REPLACES: Please discard bulletin MC20-10 dated November 5, 2020.

**TITLE: '18~'20 NINJA H2TM SX, SX SE & SX SE+
MISSED SHIFT RPM CONTROL REPROGRAMMING**

RECALL

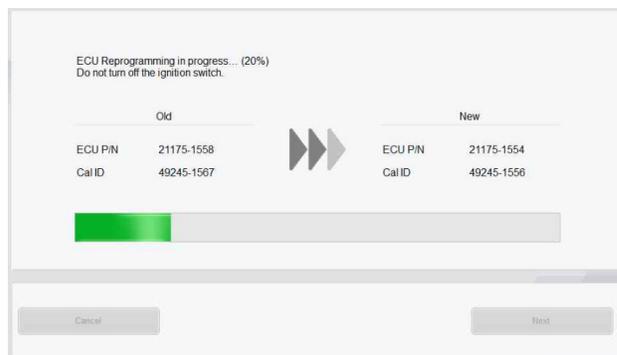
- Click on the “Next” button once the download is complete to start reprogramming the ECU.

Old		New	
ECU PIN	21175-1558	ECU PIN	21175-1554
Cal ID	49245-1567	Cal ID	49245-1556

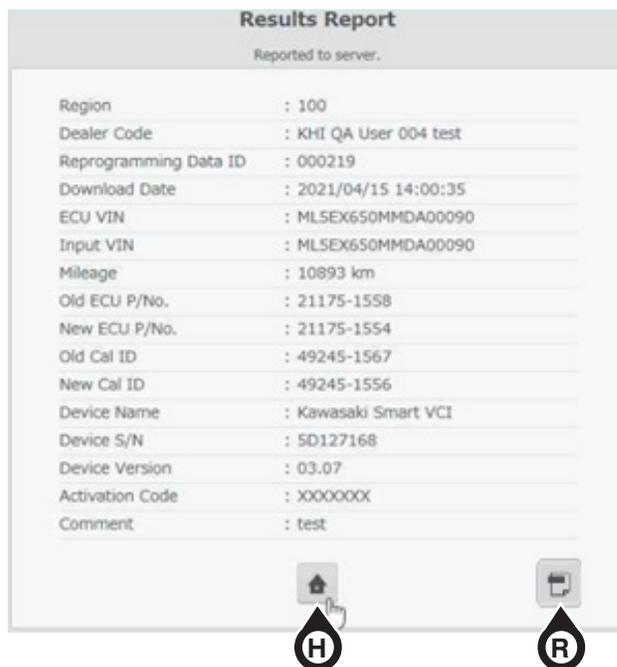
- Wait for the reprogramming to finish.

- o Do not disconnect any of the connections during reprogramming.
- o Do not turn off the KVIC device during reprogramming.
- o Do not shut down KVCS during the reprogramming.
